SECTION 8.00-9.00 Planning Pre-App’s DM/23/1480 & DM/25/0133

Responses to and Comparables with Current Full Planning/Listed Building Consent Applications

8.00 Pre App DM/23/1480 and Current Proposal Responses & Comparables

8.06 Site Works & Landscaping

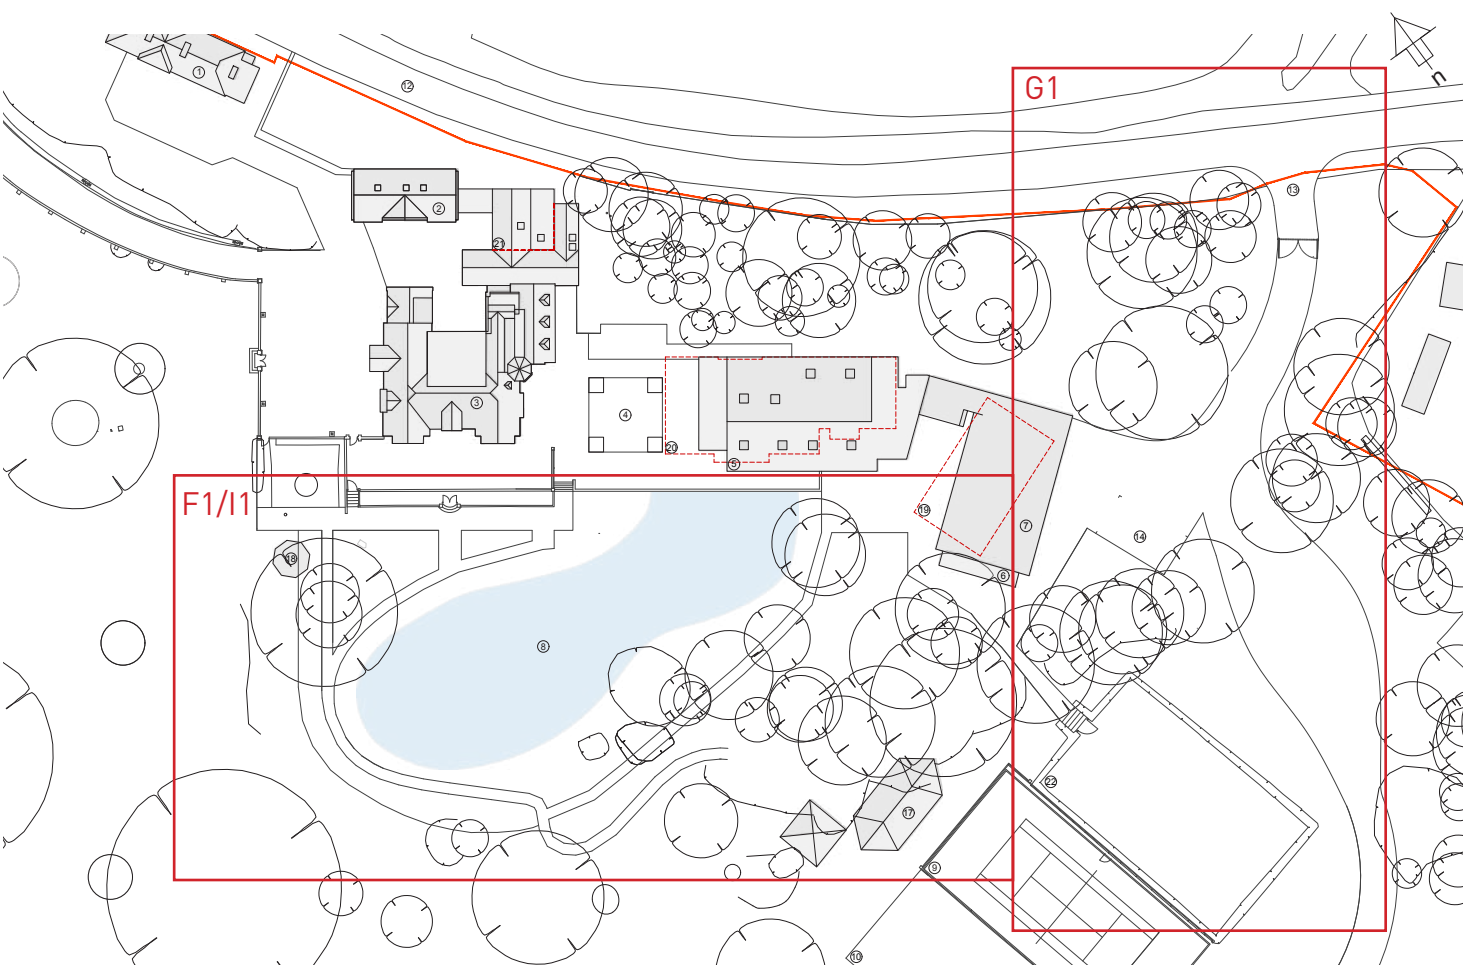
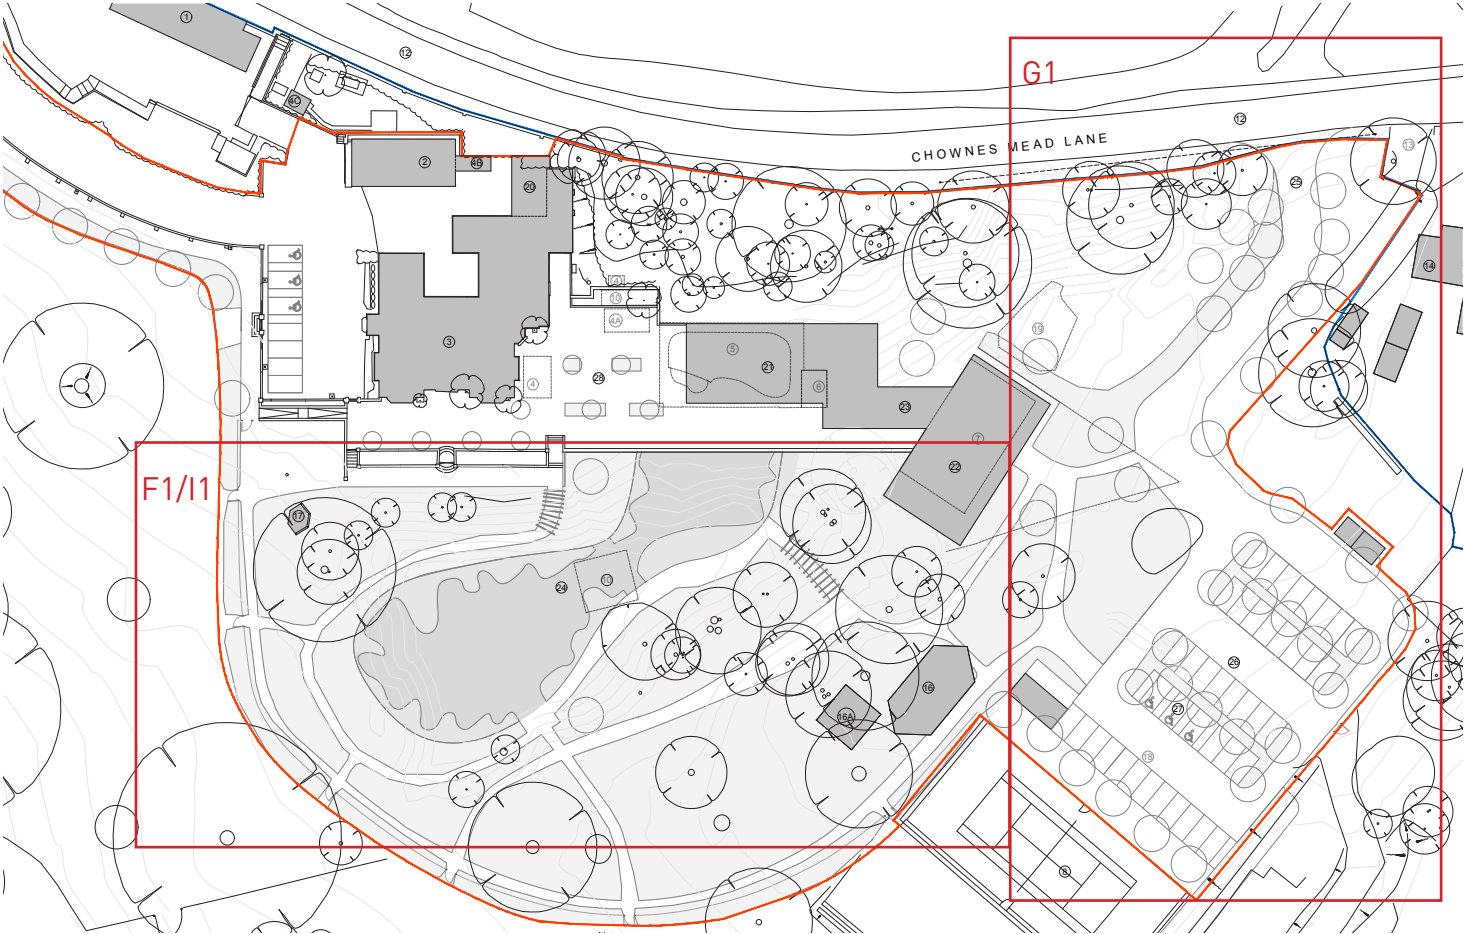
'The reinstatement of the pond within the dell is not considered contentious, and may be considered beneficial, if this is shown to be part of the original Jekyll plans for the garden, and in particular if accompanied by other, appropriately informed, restoration of historic garden features/plantings.'
- G1

'The relocation of the secondary entrance from Chownes Mead Lane is not considered contentious subject to detail including of the impact on any planting/trees to the boundary. Likewise the proposed parking area may be acceptable subject to detail, given the existing hard standing in this position. A detailed hard and soft landscaping scheme would be required to demonstrate that there is no adverse impact on the garden setting of the house.'
- I1

'Another area of concern is the possibility of contaminated land, particularly with regard to the old pond. Our mapping suggests that the old pond was infilled with made ground. It is important to highlight that "made ground" refers to land that has been altered or disturbed by human activities such as construction, excavation, or waste disposal. This type of land has the potential to contain pollutants, although it is currently unknown what contaminants, if any, might be present.'
- I2

'Upon visiting the site, it was apparent that the pond area still possesses considerable depth, so it is unclear how much made ground could have actually been placed. However, I would still advocate for a phased approach to address this concern. Given the planned redevelopment of the site, I would recommend, at the very least, conducting a desktop study to determine whether any further investigation or remediation efforts are necessary. This phased approach, including the need for a preliminary study, can be conditioned if there is a desire to obtain permission before commencing such an in-depth investigation.'

Reference should be made to all drawings and documentation by Nicholas Dexter Landscaping Design in conjunction with the proposed pond within the dell as well as the Jekyll influenced sensitive landscaping and garden design which marries with the architectural approach, responding wholly to the listed building and heritage setting.
- G1

Reference should be made to all drawings and documentation by Nicholas Dexter Landscaping Design in conjunction with both the drawings and report from Motion Transport Consultants, and the approach set out in the Ancient Woodland dialogue within the DAS.

The suggestion of a phased approach and Condition applied to this is acknowledged and agreed as the most sensible way to approach this element.

9.03 Place Services Consultation: Areas 1 - 6 (to be read with summary 9.04)

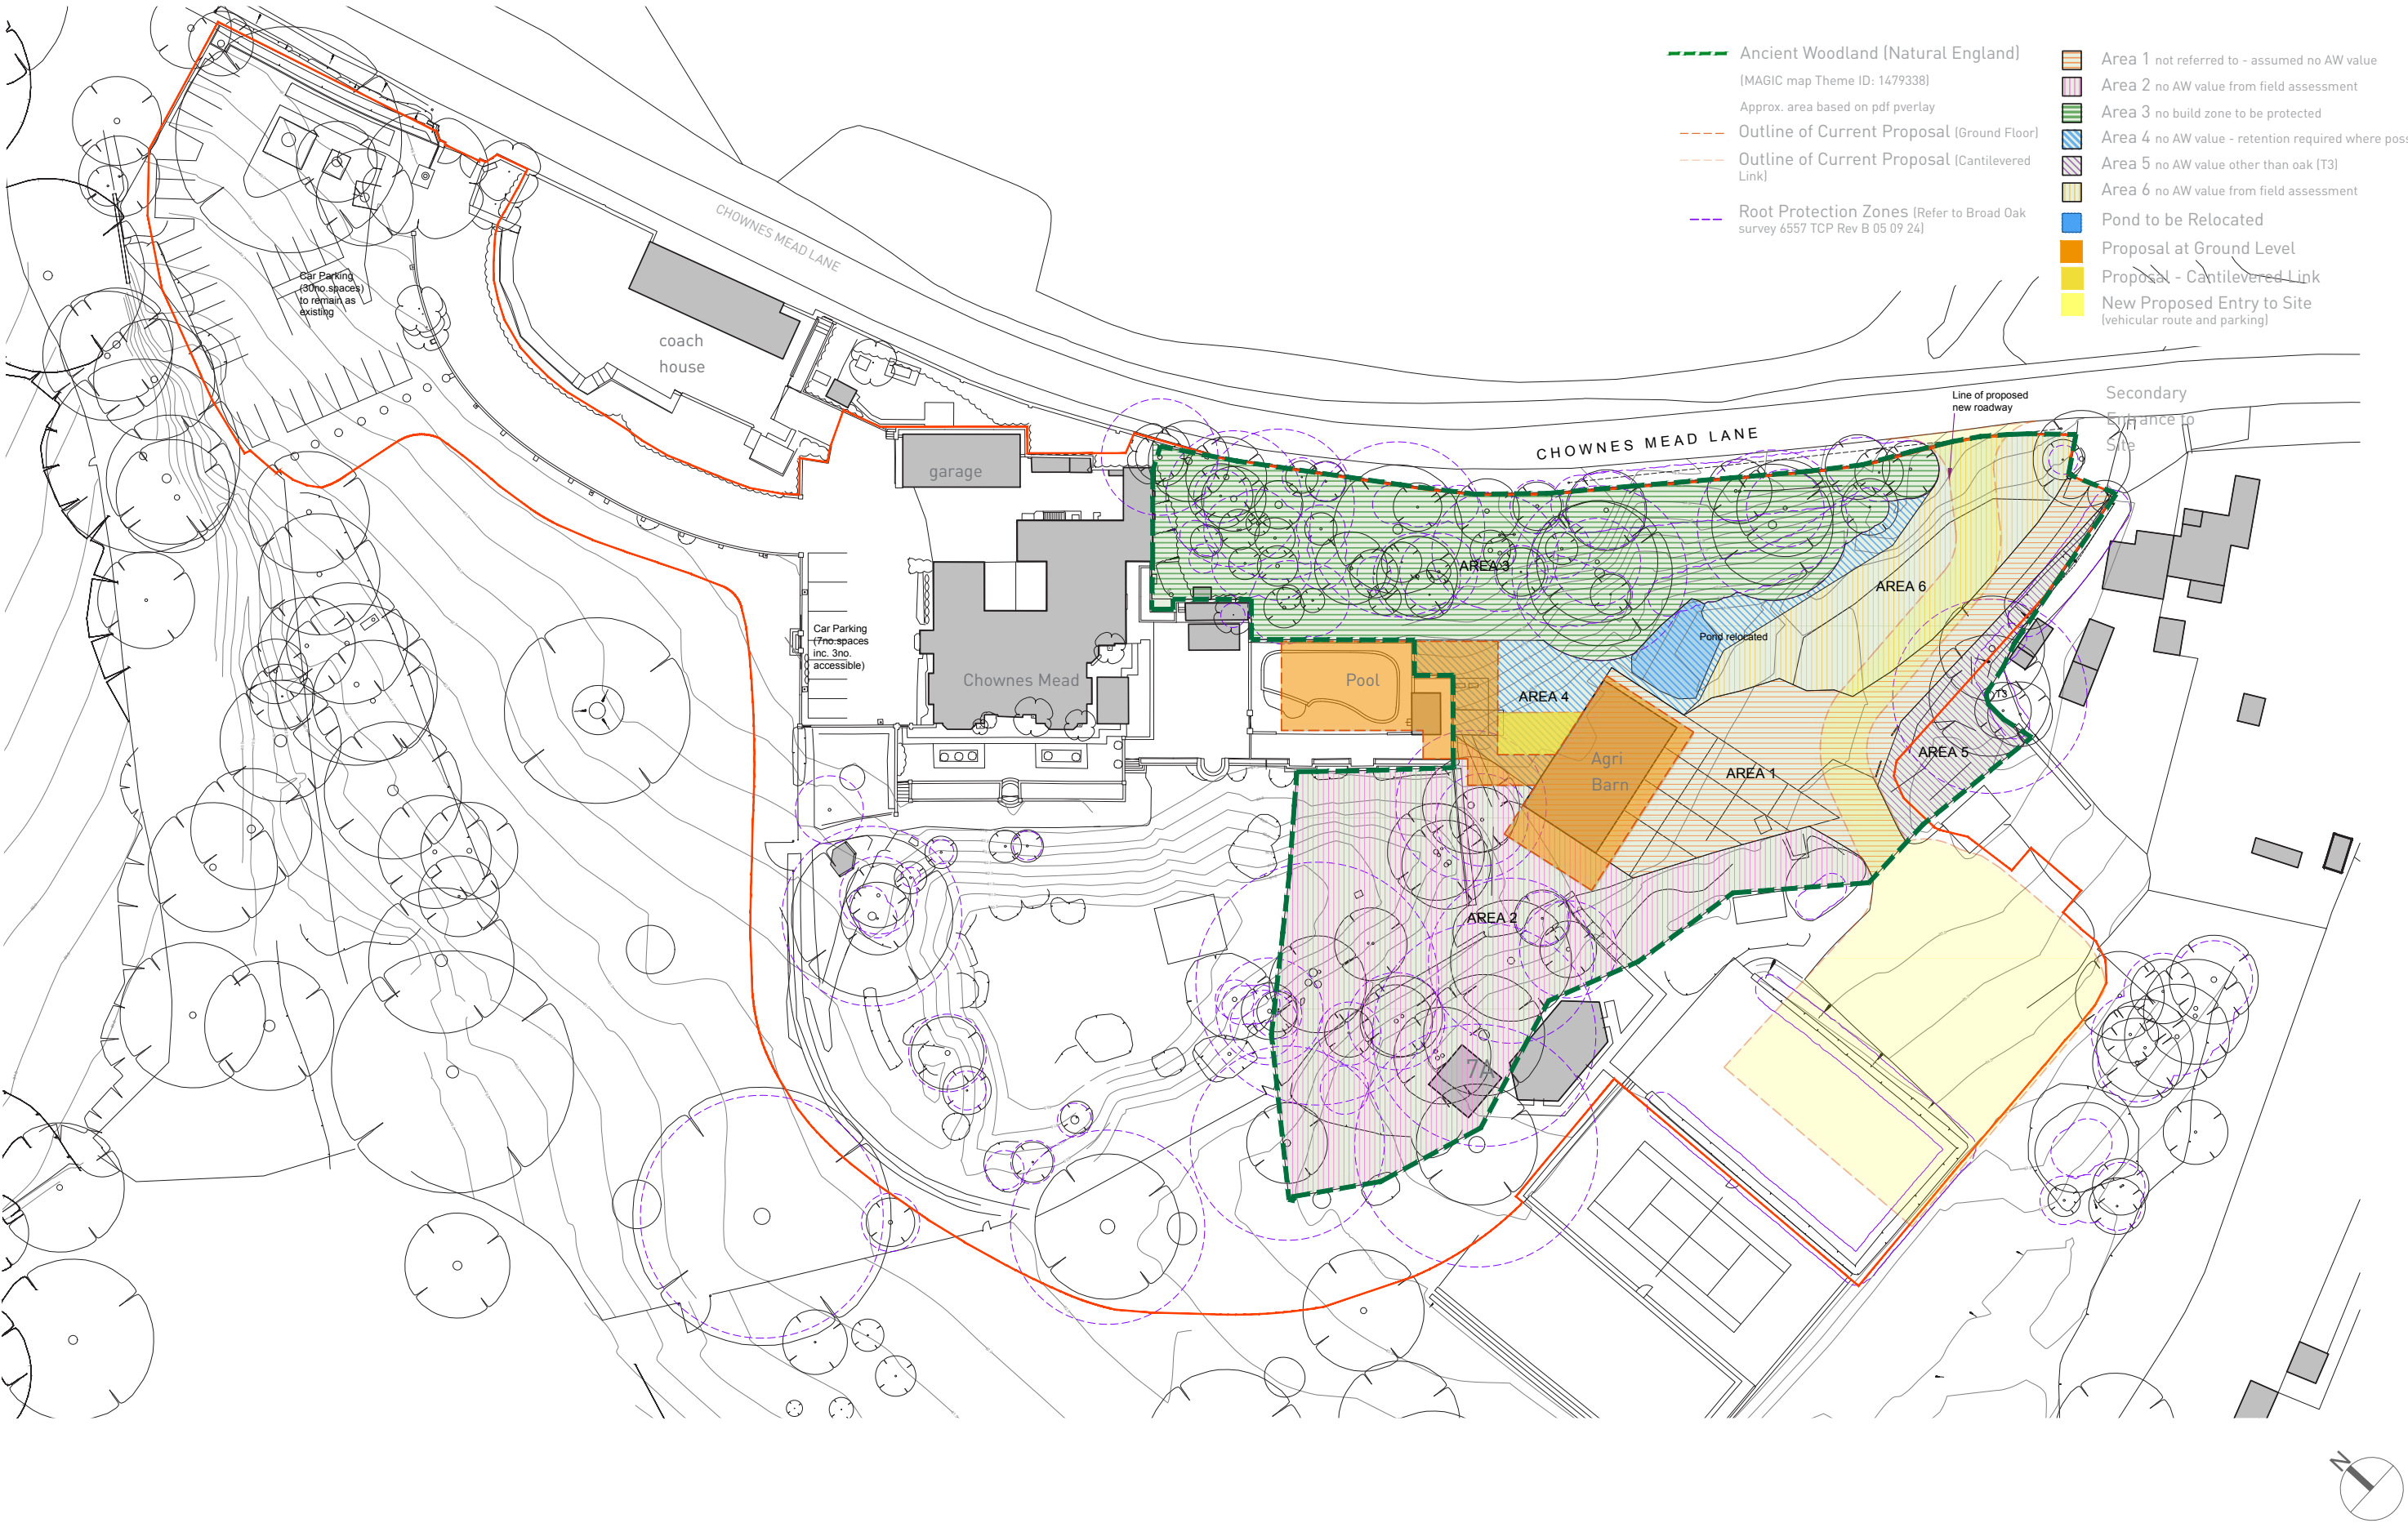
Based on the site visit carried on the 1st May 2025, it is acknowledged that the majority of the site is no longer functioning as Ancient Woodland, with most of the site classified as ‘developed land; sealed surface’. As a result, a pragmatic approach is required for any subsequent application to demonstrate compliance under the NPPF 2024, following the previous loss of irreplaceable habitat permitted as part of historic planning applications. (1)

It is agreed that the trees within location 2 in the ‘Assessment of Ancient Woodland’ included abundant non-native specimens, which included Coastal redwood, holm oak, Monterey cypress and wellingtonia. Whilst this area has retained a continuously wooded area, it was noted that the ground within the site had been reprofiled and no evidence of ancient woodland indicator species were present during an optimal survey period. Therefore, it is agreed that this is area does not hold the value of an Ancient Woodland from a field assessment. (2)

However, the small strip of woodland to the east of the site (referenced as location 3 in the ‘Assessment of Ancient Woodland’ does contain the following ancient woodland indicator species1: Buebell, Wood anemone, Wood speedwell and Primrose. Therefore, it is agreed that this area forms part of the remnant Ancient Woodland and should be protected from any proposals. (3)

The area referenced as location 4 in the ‘Assessment of Ancient Woodland’ was adjacent to a pond and dominated by Pendulous sedge, Rhododendron, Willow sp. and Bramble agg. Therefore, it is highlighted that Pendulous sedge is another ancient woodland indicator, where the species have clearly not been planted. Therefore, if this species were not planted, there is a possibility that the ground flora does indicates remnant woodland habitat. Nevertheless, given the pond in close proximity, we do not consider that this is strong indicator species. As a result, it is not considered reasonable that this area should be classified as ancient woodland, following the permitted clearance works. However, the pond and surrounding habitat should be retained as much as possible within the proposed designs.(4)

It is also agreed that location 5 referenced within the ‘Assessment of Ancient Woodland’ consists of a single Oak tree beside a Cherry laurel hedge. It is not clear when this Cherry laurel hedgerow was planted, but the only remnant of the ancient woodland is the Oak tree, with no ancient woodland indicator species. (5)

With regard to location 6 referenced within the ‘Assessment of Ancient Woodland’, it is agreed that this area contains imported and disturbed soils and contains a mixture of bramble and grassland species. No obvious ancient woodland indicator species were present at this location and therefore it is agreed does not hold the value of an Ancient Woodland from a field assessment. (6)

As a result, the planning application submission will need to demonstrate how further direct and in direct impacts will be avoided on the remaining woodland area (location 3). This could be included within the finalised Ecological Impact Assessment and should be in line with Government standing advice: Ancient woodland, ancient trees and veteran trees: advice for making planning decisions - GOV.UK. (7)

However, given the extent of the remnant woodland remaining, it is not considered that a buffer zone of 15m will be reasonable and instead the applicant should demonstrate that root protection areas will be protected as part of an Arboricultural Impact Assessment in line with British Standard BS 5837 ‘Trees in relation to demolition, design and development’. The finalised proposals will then be outlined as part of a Construction Environmental Management Plan, to be secured as a pre-commencement condition of any consent. The development should be designed around retaining the remaining remnant ancient woodland and the design should evidence that the natural buffers are provided around this habitat are retained / enhanced where possible. Furthermore, invasive species should be removed to minimise potential encroachment to the ancient woodland and other local woodland habitats. It is also understood that there may be an intention to amend the access of the site to the Pool House. Therefore, at an ecological perspective, the access should be retained in the first instance. However, if this is considered a necessary element as part of the proposals, this should ideally be undertaken without removal of the existing trees, along with evidence that the remnant woodland will be protected and buffered. (8)

(1) As Place Services state, it is acknowledged that the majority of the site is no longer functioning as Ancient Woodland, with most of the site classified as ‘developed land; sealed surface. Thus, as recommended, the Design team has taken a pragmatic approach in demonstrating compliance under the NPPF 2024 as suggested and as referred to earlier in this section.

(2) the design team acknowledges that it is agreed that location 2 in the ‘Assessment of Ancient Woodland’ does not hold the value of an Ancient Woodland from a field assessment. This area has therefore been considered as suitable for the location of some limited elements of the proposals including reinstating the pond in the dell (part of which falls outside area 2).

(3) The small strip of woodland to the east of the site (referenced as location 3 in the ‘Assessment of Ancient Woodland’) does contain ancient woodland indicator species. The design team acknowledges that it is agreed that this area forms part of the remnant Ancient Woodland and should be protected from any proposals. With this agreed, the proposals do not enter this area whatsoever and in addition, the area directly adjacent has been highlighted to form part of a schematic study produced by Reeve Structures (Structural Engineer) where the foundations and groundwork for the built form are carefully considered and designed to avoid any impact on area 3 during the construction process.

(4) The area referenced as location 4 was adjacent to a pond. It is not considered reasonable that this area should be classified as ancient woodland, following the permitted clearance works. However, the design team acknowledges the pond and surrounding habitat should be retained as much as possible within the proposed designs.

(5) the design team acknowledges that It is agreed that location 5 consists of a single Oak tree beside a Cherry laurel hedge....but the only remnant of the ancient woodland is the Oak tree, with no ancient woodland indicator species. The proposals retain the oak tree insitu including its root protection zone with no construction to take place locally.

(6) the design team acknowledges and agrees location 6 contains imported and disturbed soils and contains a mixture of bramble and grassland species. No obvious ancient woodland indicator species were present at this location and therefore it is agreed does not hold the value of an Ancient Woodland from a field assessment. Part of this area is proposed to accommodate the relocated secondary entrance from Chownes Mead Lane.

(8) The design team acknowledge the remnant ancient woodland (location 3) and the proposals have been carefully and respectfully designed around this. For the most the new build pool and spa building adjacent to location 3 are positioned on the existing terrace / pool areas as well as the location of the pool house and local hard-standing/ paved areas.
